**Chemung County Stormwater  
Construction Inspection  
Erosion and Sediment Control**

<b>Project Name</b> Fairport Ridge	<b>Date</b> 6-24-19
<b>Location</b> Prospect Hill Horseheads, NY	<b>Permit #</b> NYR11B689
<b>Weather Conditions</b> sunny clear	<b>Entry Time:</b> 9:52 am
<b>On-Site Representative Present:</b> Scott Mosso	<b>Exit Time:</b> 10:23 am

PROJECT: Fairport Ridge  
Town of Horseheads  
Municipal Construction Inspection  
June 24, 2019

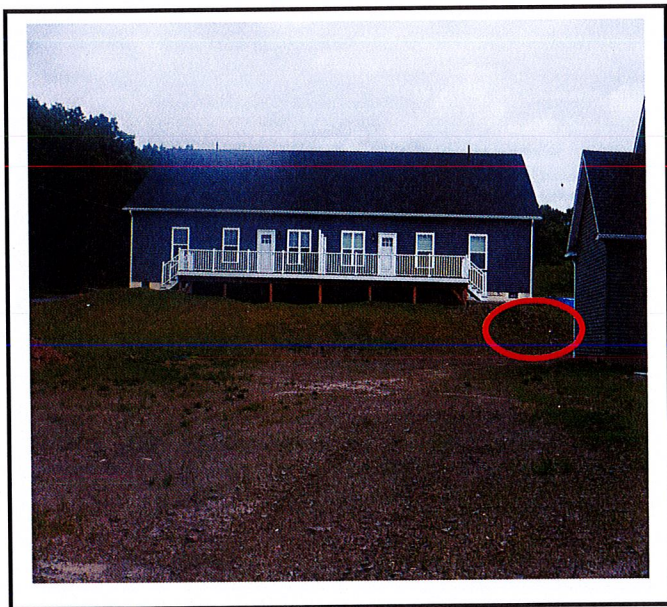
Roof drain outlets are causing minor erosion. Owner will install outlet protection.
